<http://dec.vermont.gov/watershed>**AUTHORIZATION TO CONDUCT STREAM ALTERATION ACTIVITIES**

Project Number: **SA-07-046-2016**Watercourse: **Neshobe River**Applicant Name: **Daryl Burlett**Email: **dburlett@townofbrandon.com**Mailing Address: **49 Center Street Brandon, VT 05733**Phone: **(802) 247-3635 x211**Project Location: **Segment 6 on VT RT 7 from High Street to Prospect Street**Lat/Lon: **N 43.7993 / W 73.0887**

FW: Brandon S6, Stream Alteration Permit

Geotextile may be under the stream bank but not under the stream bed (screen shot from sheet 2)

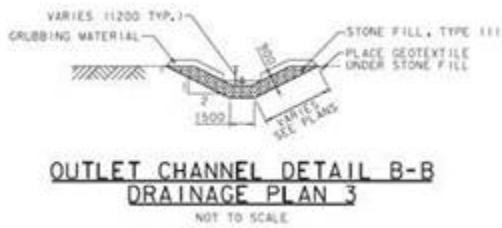
Stone fill in the stream channels will need to satisfy the ANR Type E spec (attached).

We will modify the stone channel details to call for appropriate Type E streambed stone fill at each stream location to meet the specifications you provided (attached). Since the VTrans specifications for stone fill are different, we have seen this accomplished by including a special provision pay item for the stone gradations for the E1, E2, etc. stone types so that the Contractor provides the correct stone. We will include that special provision with the project specifications. We will eliminate the geotextile lining from the stream channel details.

Station 21+880:

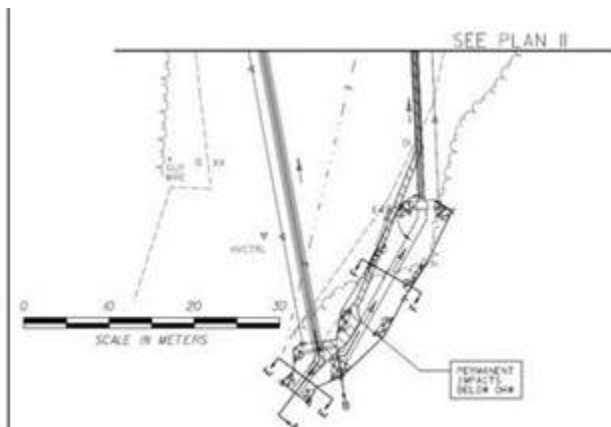
Is the screen shot below from sheet 6 showing two inlets for the stream into the relocated portion of the pipeline?
What is the purpose of two inlets?

There is proposed to be one primary inlet comprised of a 42" diameter pipe at the stream elevation with headwall. Site constraints, including minimal available cover over the pipe, prevent the use of a larger pipe. Therefore, there is a proposed overflow channel set at a higher elevation draining to a proposed 30" diameter pipe with end section that would receive stream flows only during larger storm events. Both inlet pipes are connected to the same conveyance system to the outfall. The proposed pipes would replace an existing undersized 30" diameter pipe that connects to the inlet of the existing stone box culvert which was filled over some time in the past.
